Nine Mile Point
Nuclear Station

SUBJECT: Nine Mile Point Unit 2
Docket No. 50-410
Facility Operating License No. NPF-69

License Amendment Request: Revise Standby Liquid Control System Sodium
Pentaborate Solution Requirements, Technical Specification 3.1.7

Figure 3.1.7-1 (Page 1 of 1)
Sodium Pentaborate Solution Volume/Concentration Requirements

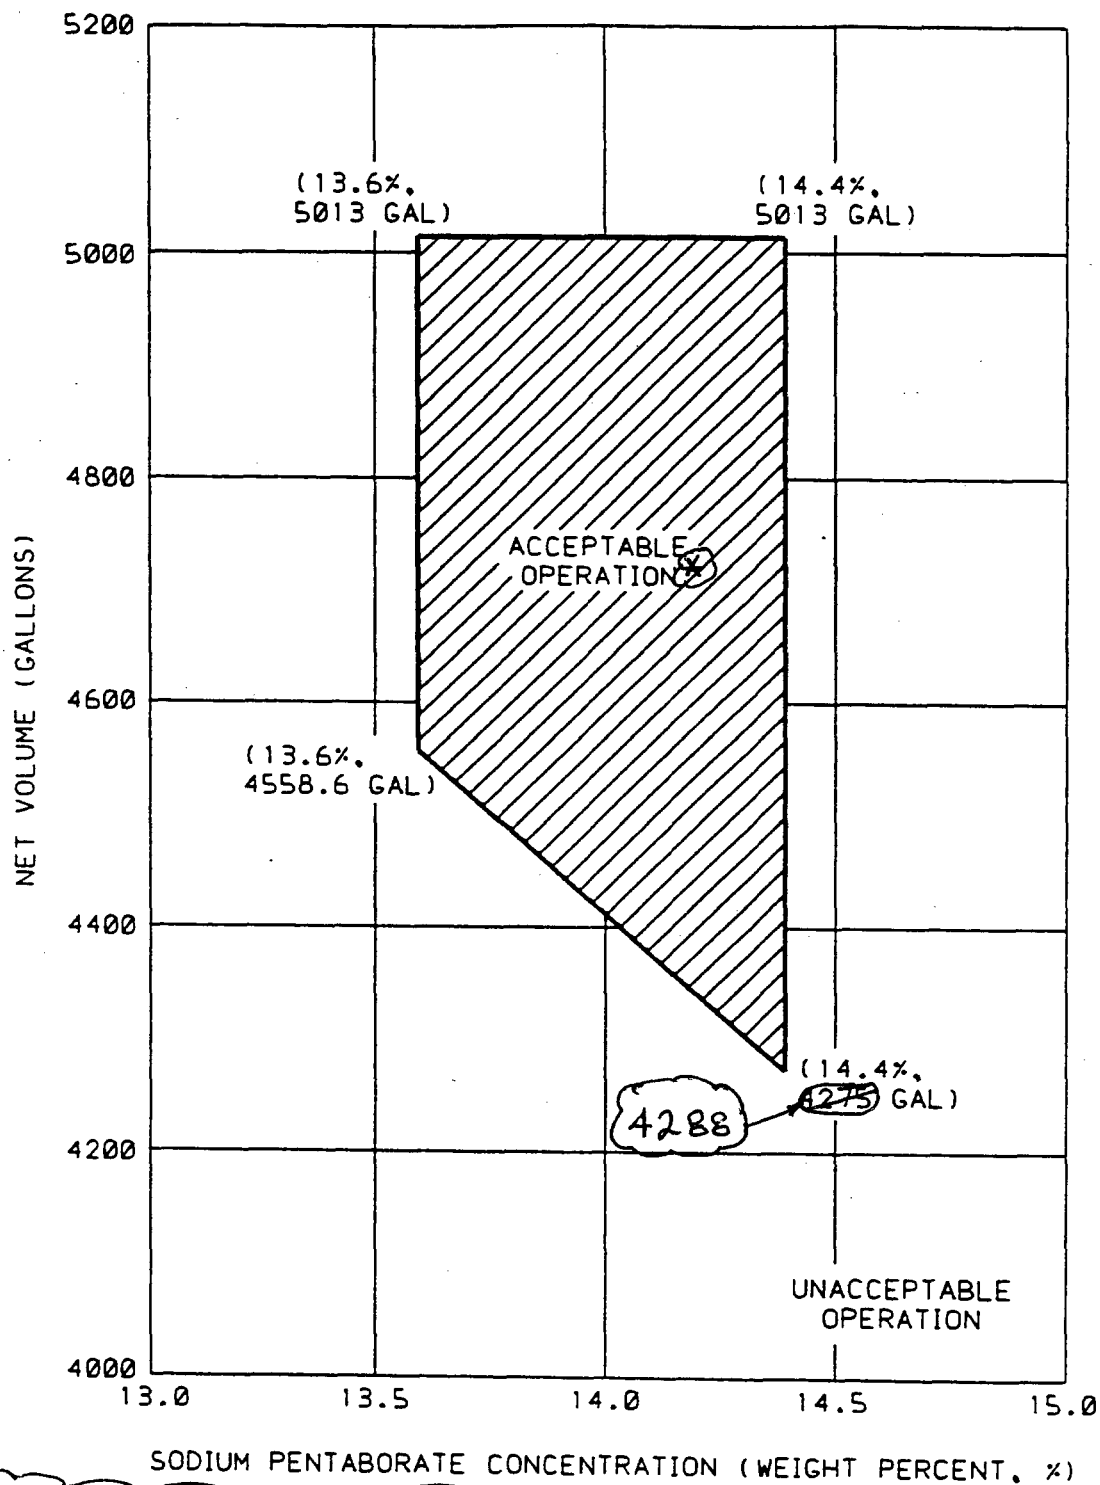
NMP2 TS SR 3.1.7.1 and SR 3.1.7.5 require that the available volume and concentration of sodium pentaborate solution in the SLC tank be within the limits of TS Figure 3.1.7-1. Figure 3.1.7-1 consists of a graph that defines acceptable SLC tank volume and concentration values, such that the required boron concentration in the reactor core will be achieved. The proposed change revises Figure 3.1.7-1 by adding a notation regarding the required Boron-10 enrichment, consistent with the proposed new SR 3.1.7.10. In addition, a minor adjustment is being made to one of the coordinates that define the Acceptable Operation region of Figure 3.1.7-1. The current concentration/volume coordinate of 14.4 percent/4275 gallons is changed to 14.4 percent/4288 gallons. This adjustment resulted from different roundoff techniques utilized in the prior volume calculation versus the present calculation.

* For Boron-10 Isotope Enrichment ≥ 25 Atom Percent
